WORKSHOP AGENDA

Planning Commission

April 16, 2024 @ 5:30 PM

Item Title: Site Plan - UHAUL, Phase 2 - Two (2) Buildings Totaling Approximately 43,000 Square Feet on 10 Acres. Requested by SEC, Inc. Property located at 503 New Paul Road (Tax Map 17, Parcel 40.03). I-2 (Heavy Industrial) Zoning District. Property owned by Amerco Real Estate Co. **(WITHDRAWN)**

UTILITY PLAN

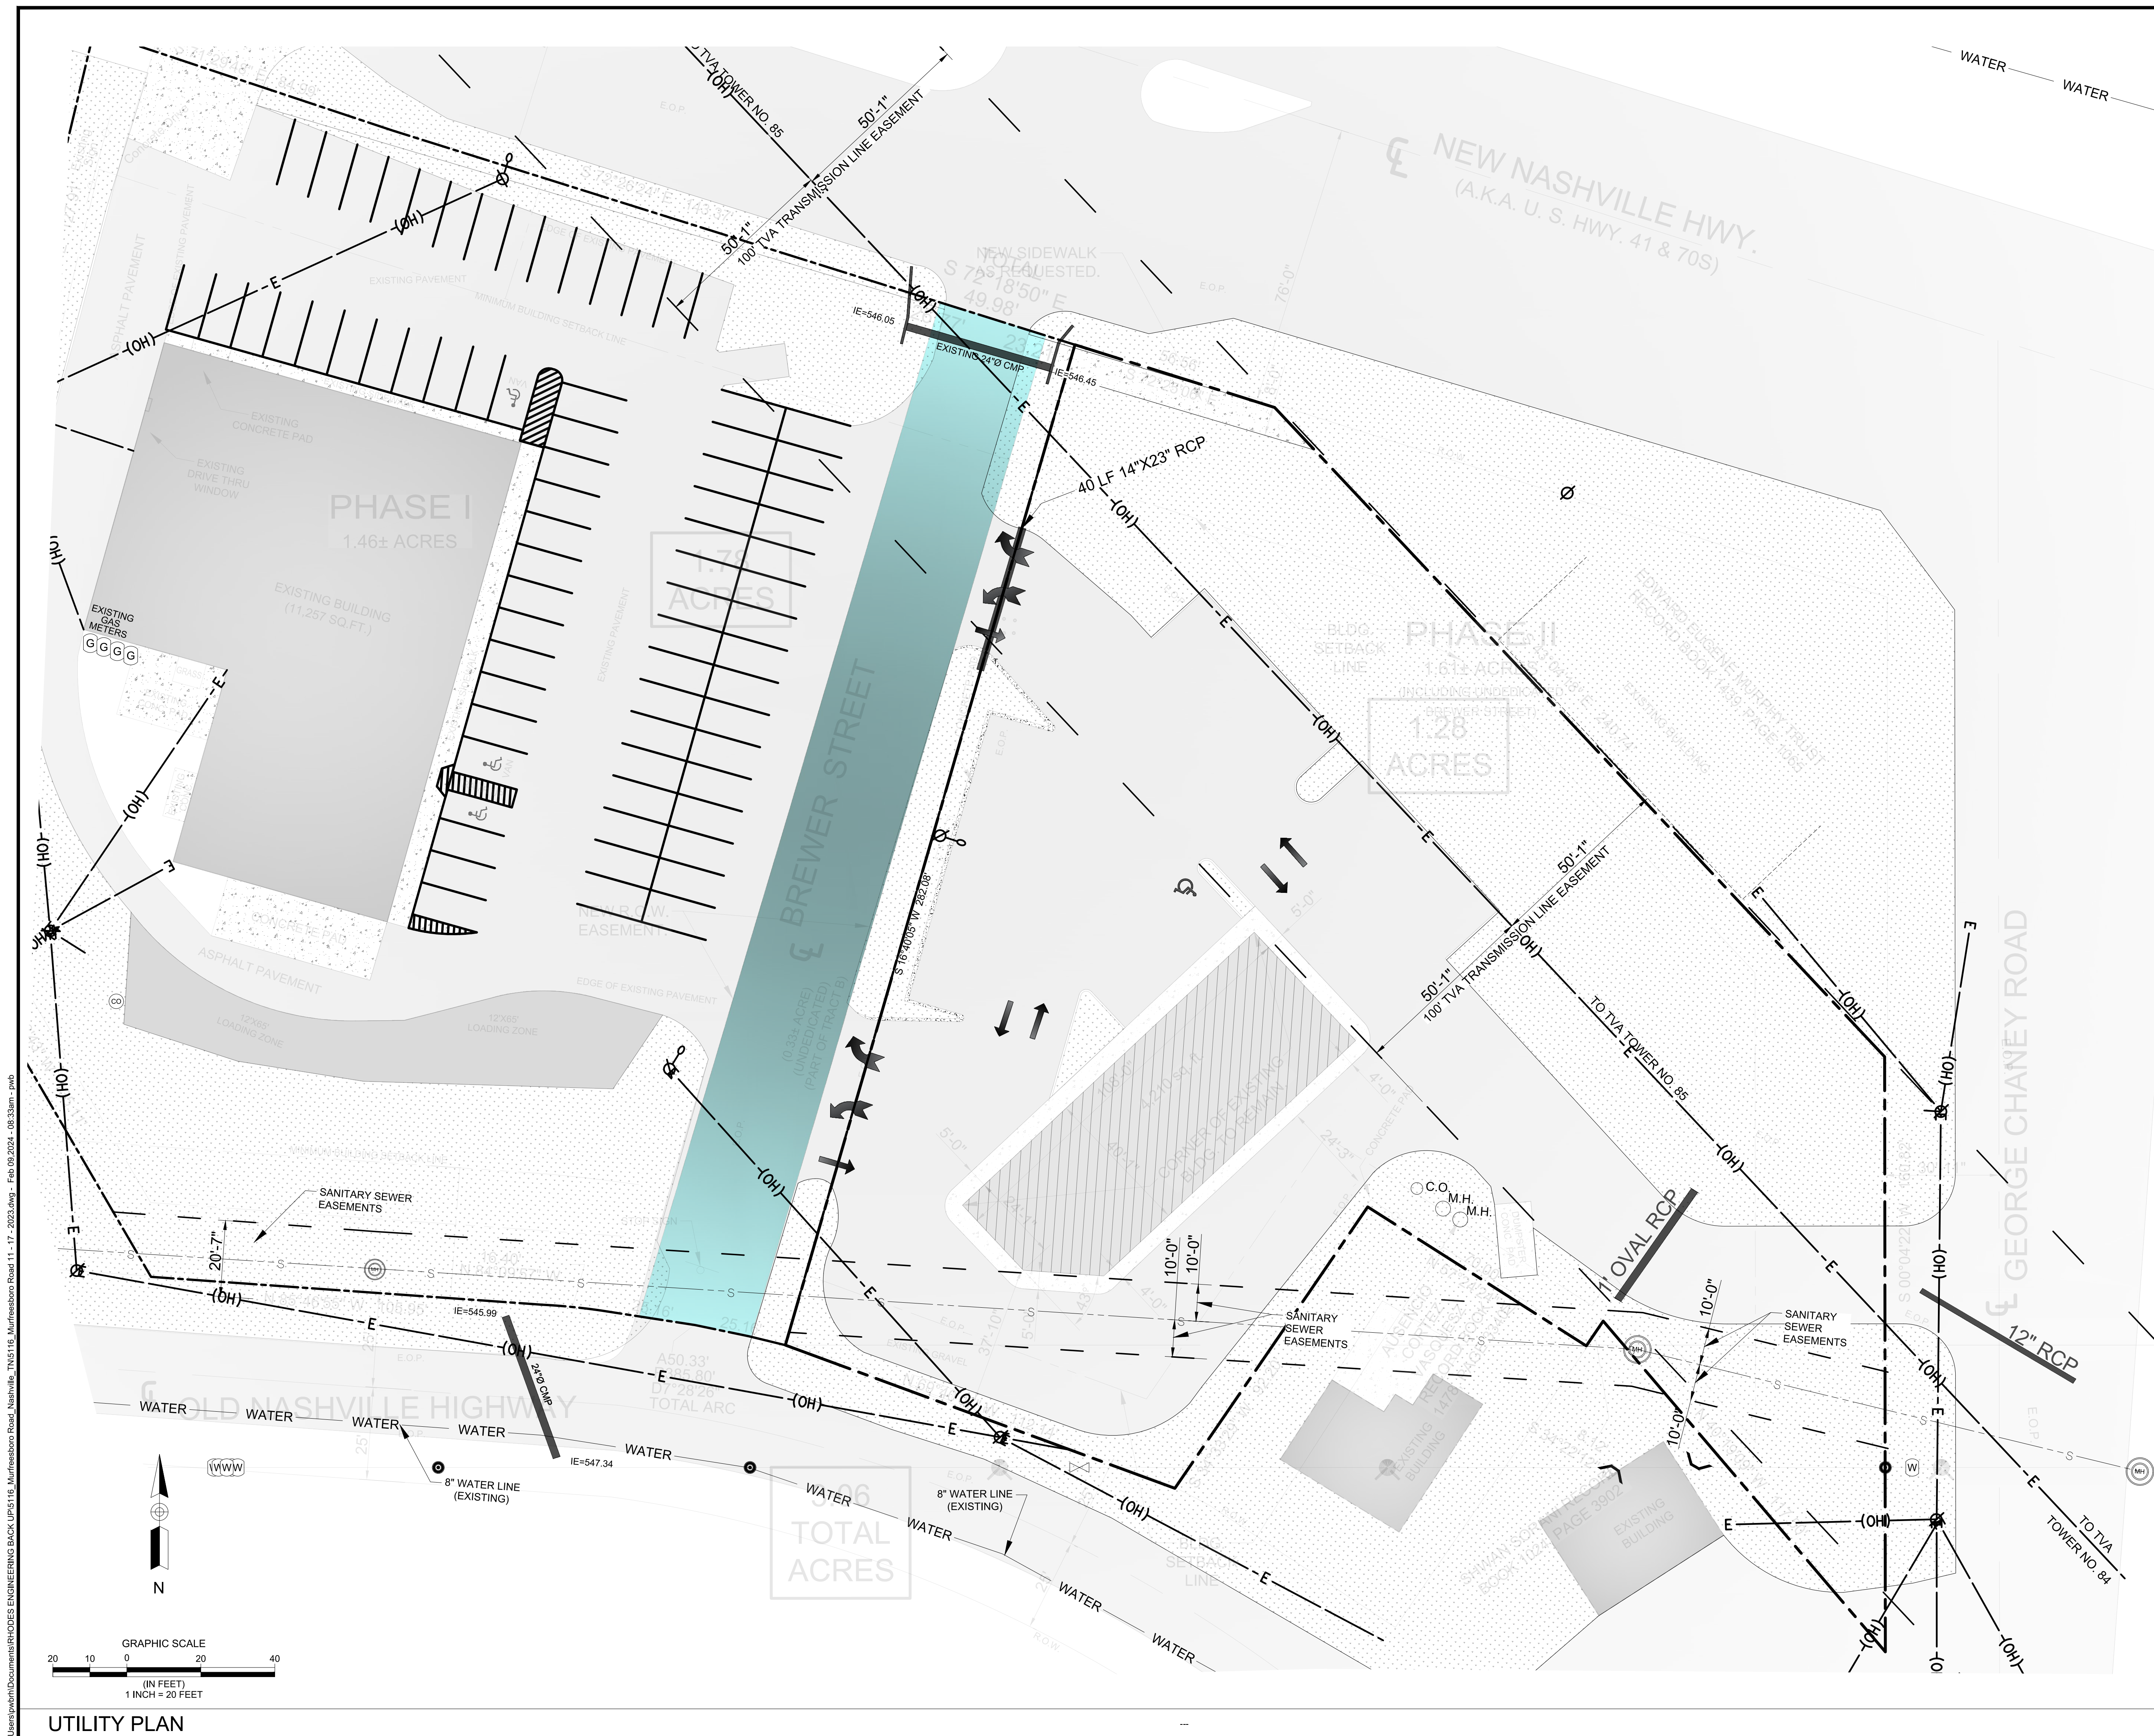
7. Provide erosion prevention and sediment control (EPSC) plans meeting the requirements of the Stormwater Management Ordinance. See Item 2 above.
8. (C-4.0) Show utilities serving proposed building even if they are existing. Engineer's response is that utilities are shown based on the survey which they were given. Staff considers the submittal incomplete.
